Re: Monitoring, Reporting and Verification (MRV) Plan for Cotton Cove CCS 1

Technical Review of Subpart RR MRV Plan for Cotton Cove CCS #1

July 2025

Figure 8. Map showing the location of wells used in the formation fluid chemistry analysis. The Cotton Cove CCS 1 location is shown with the yellow star. North is up.

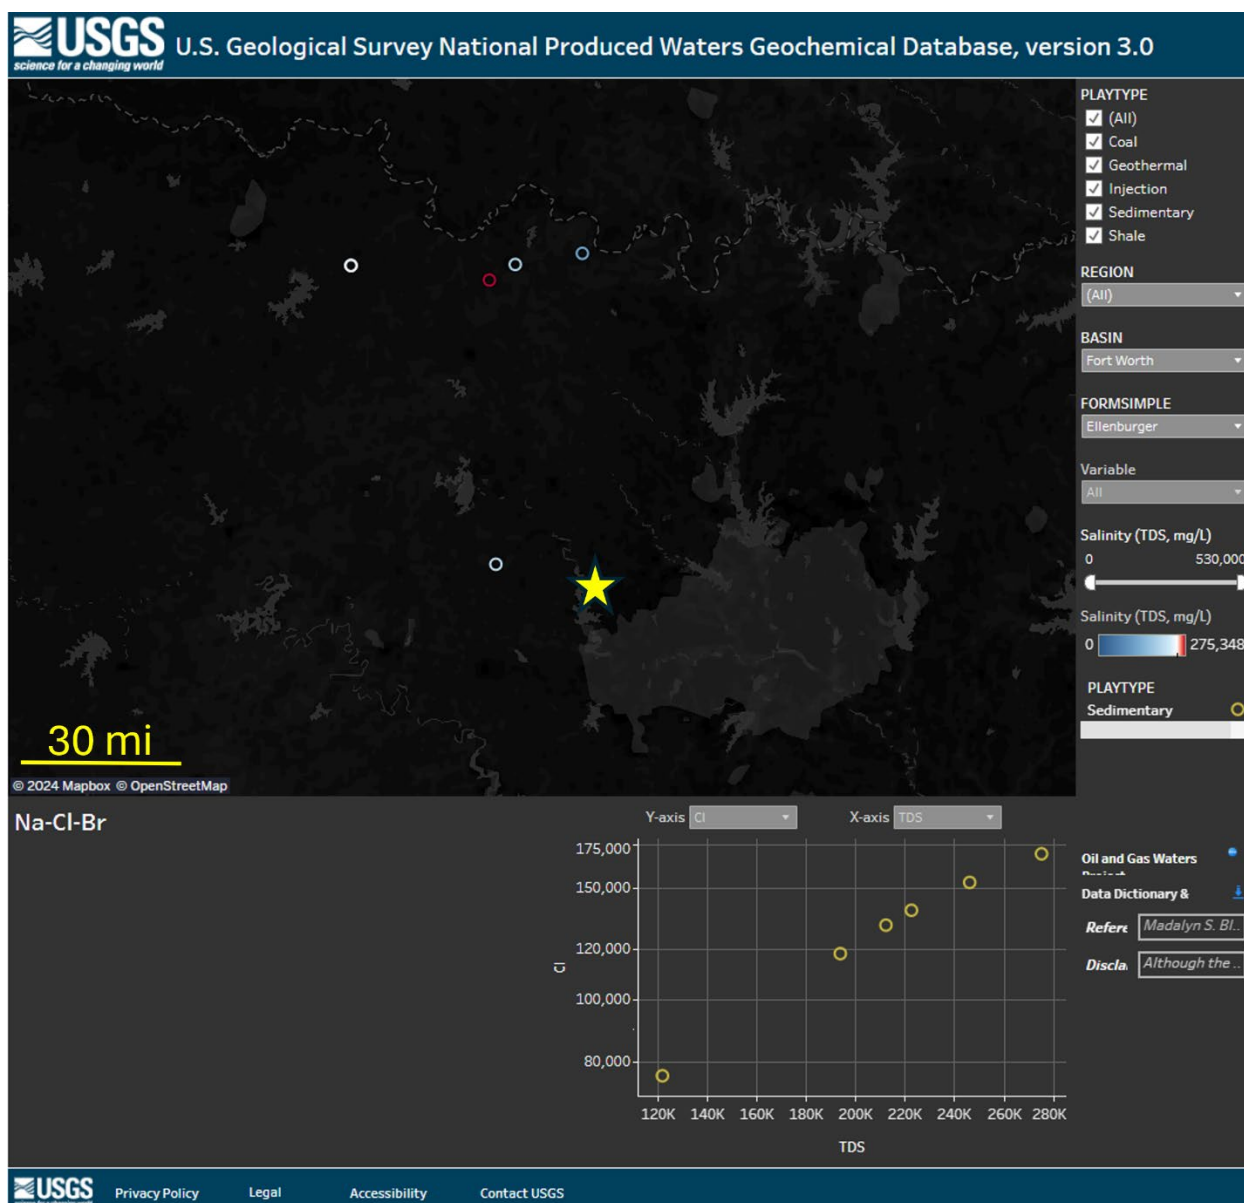
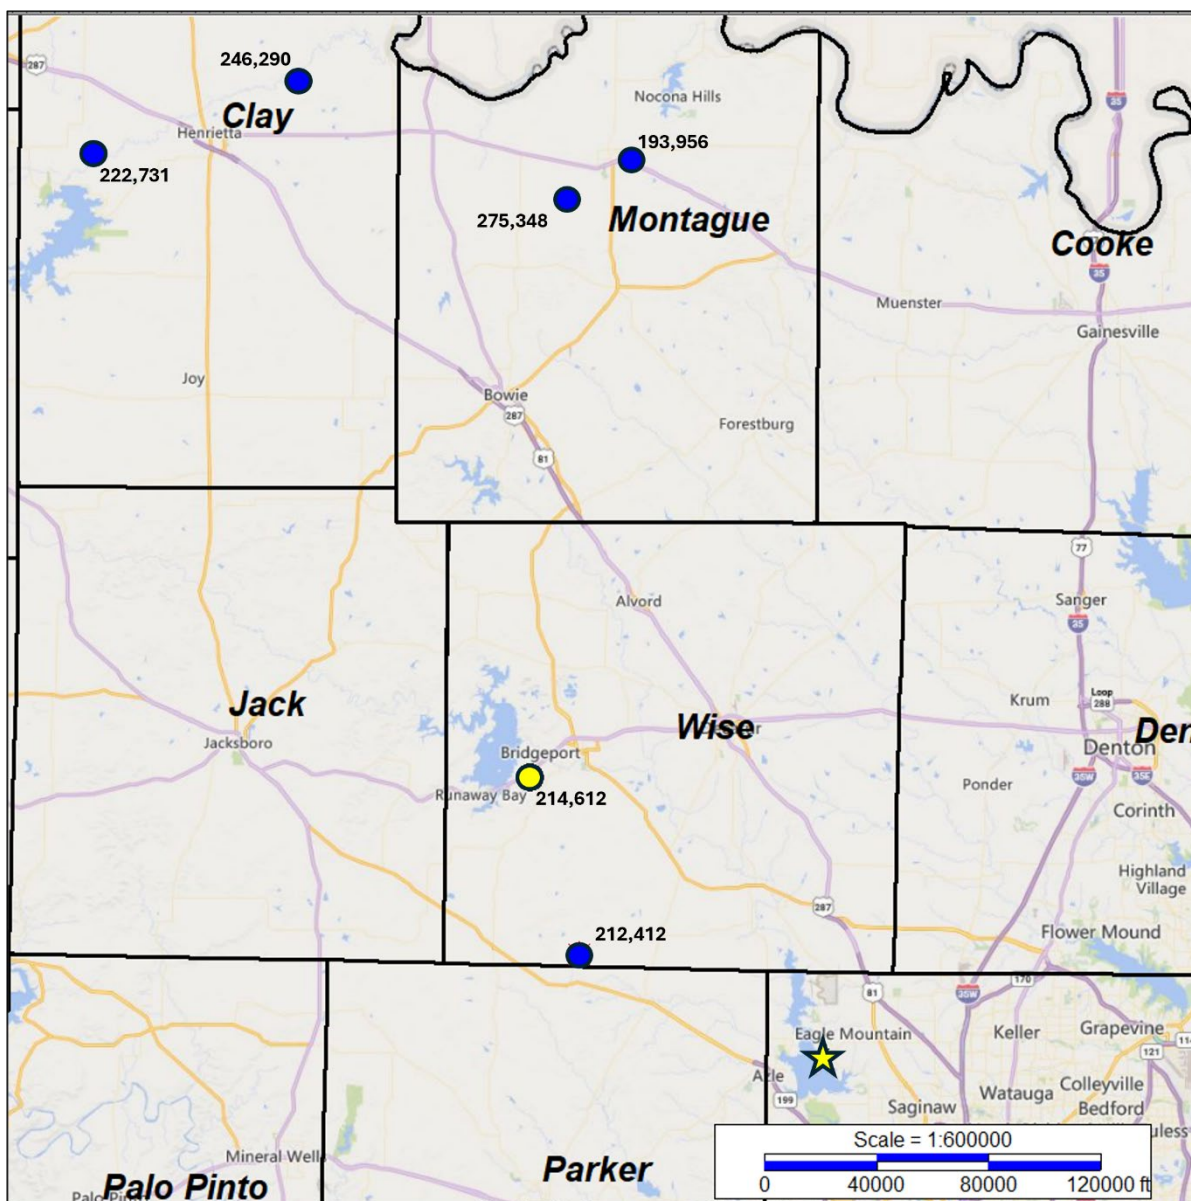
No.	MRV Plan		EPA Questions	Responses
	Section	Page		
1.	3.4	14	We recommend revising Figure 8 to ensure that it is legible. E.g., the injection wells and the units for fluid chemistry are difficult to interpret.	Revised Figure 8 to make it legible, updated Table 3 and Figure 8 to exclude one well outside of the Fort Worth Basin that had been classified by the USGS as in the basin.
